# Westbound Market St Bicycle Detour on S 23rd St

# Walnut St Bridge

# Market St Bridge

# Flex-Post Delineators vs Bike Lane Separators

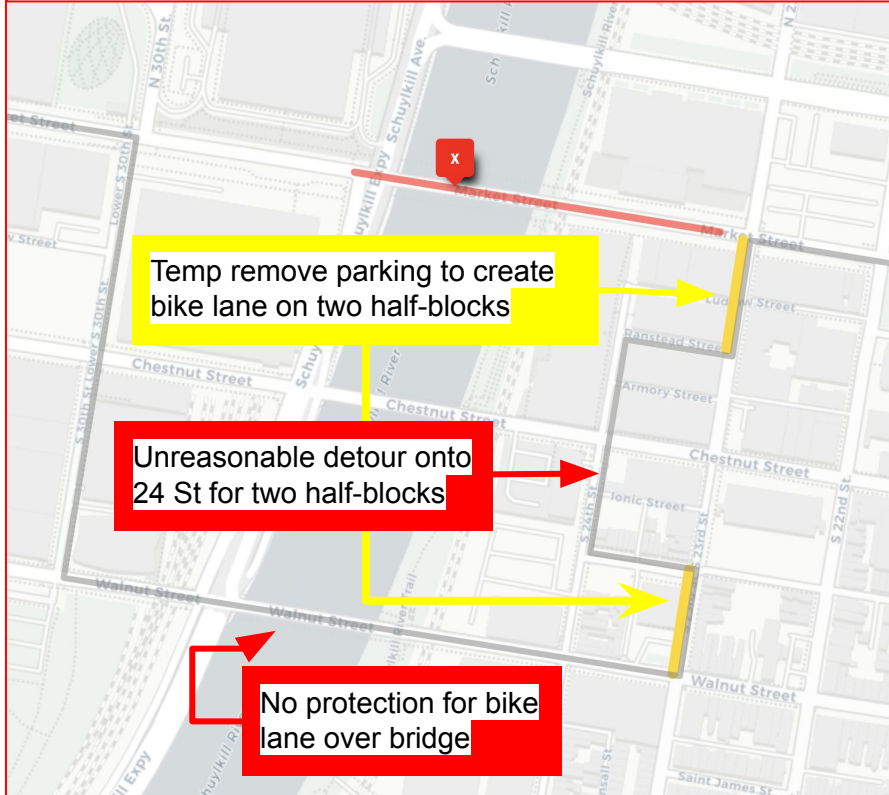
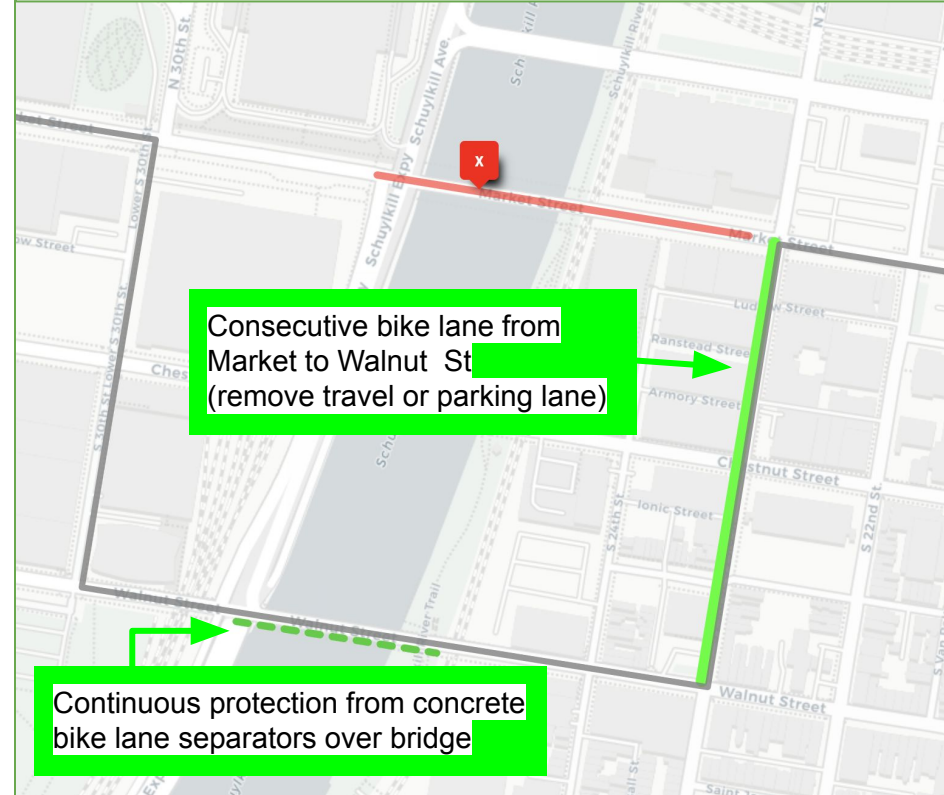
## PennDOT Plan:

## Philly Bike Action Proposal:

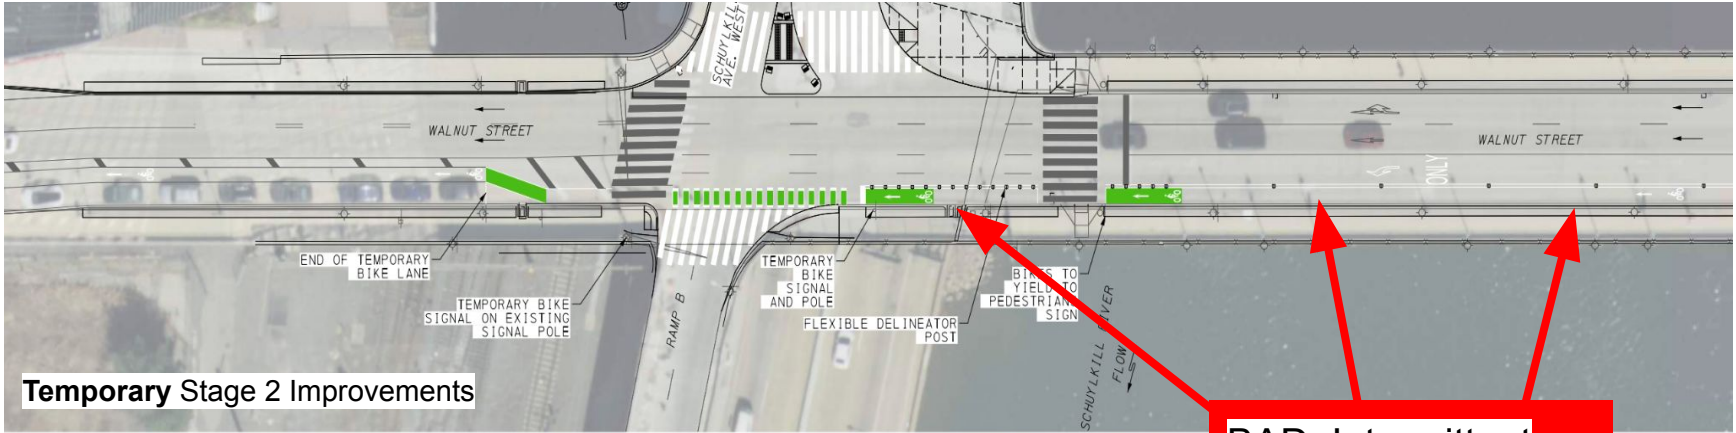
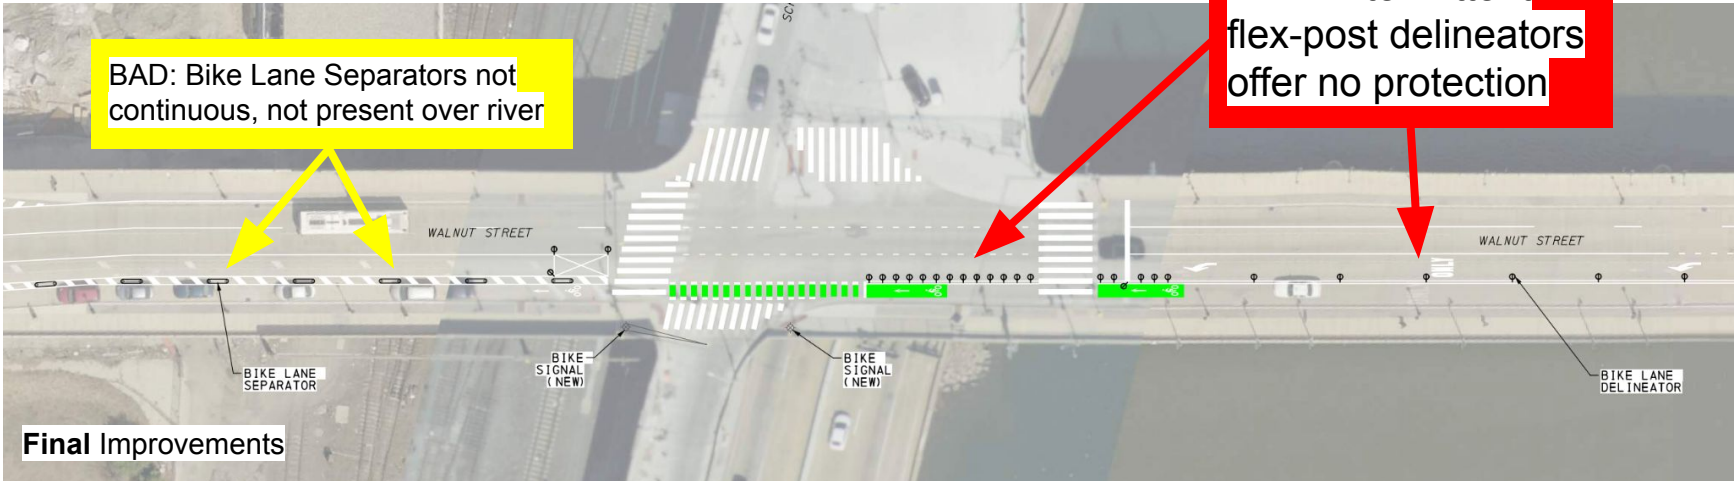
Temporary Stage 2 Improvements

Final Improvements

SR 3010, Section MSB Project Proposed Improvements  
Market Street Two-Way Bicycle Facility

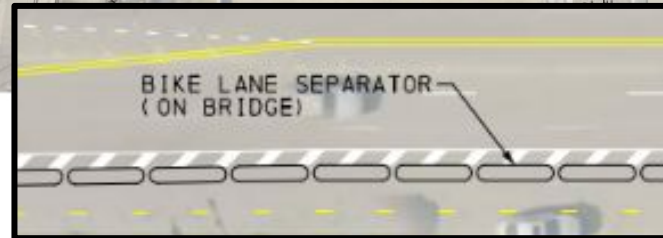
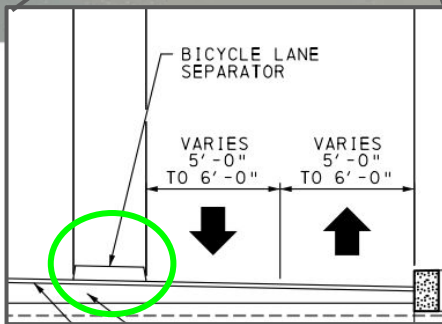
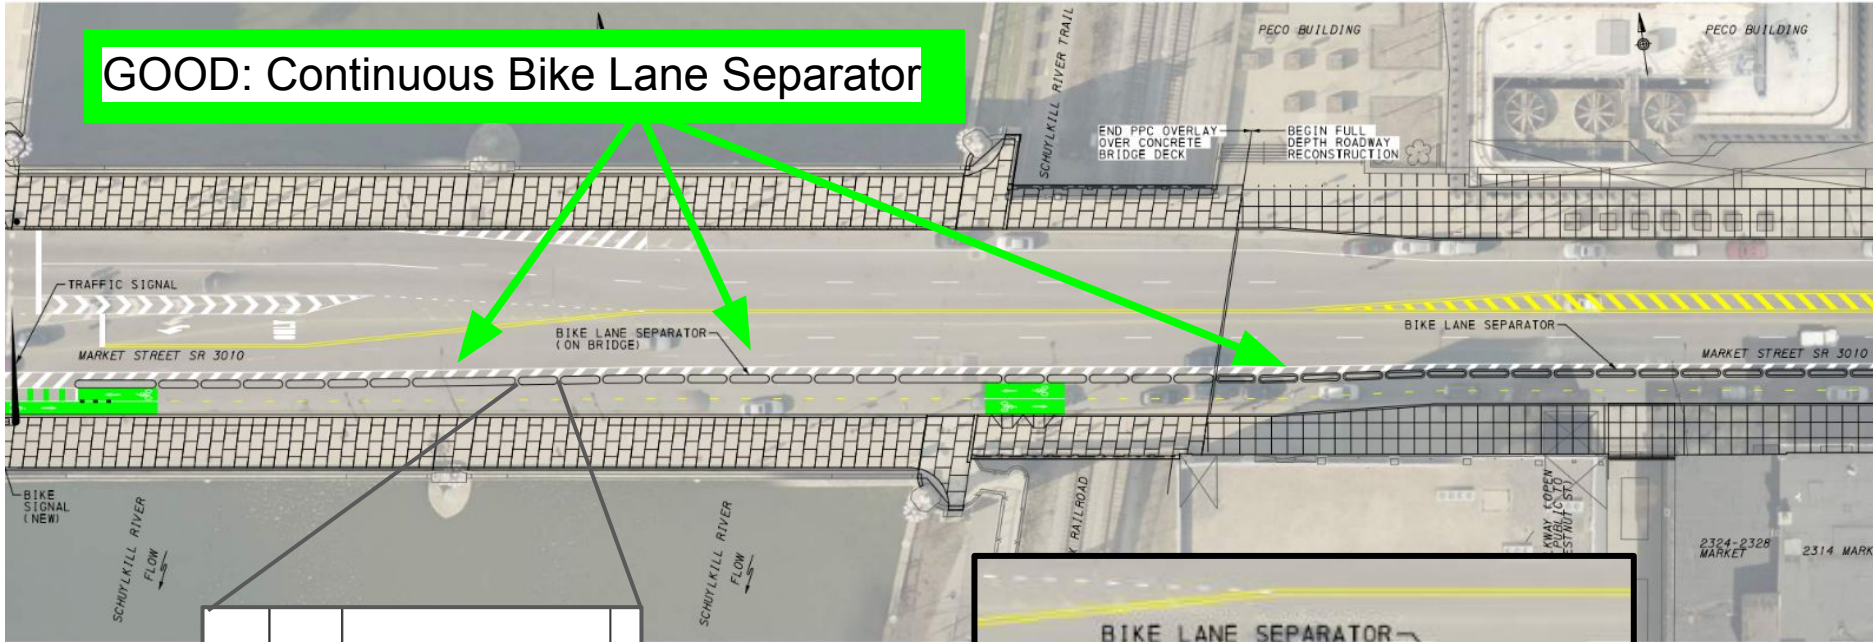
**GOOD: Continuous Bike Lane Separator**

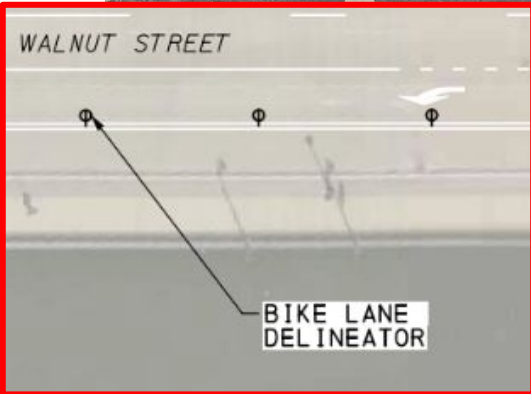
Flex-post delineators are insufficient on high-speed roads

Concrete bike lane separators provide much more protection
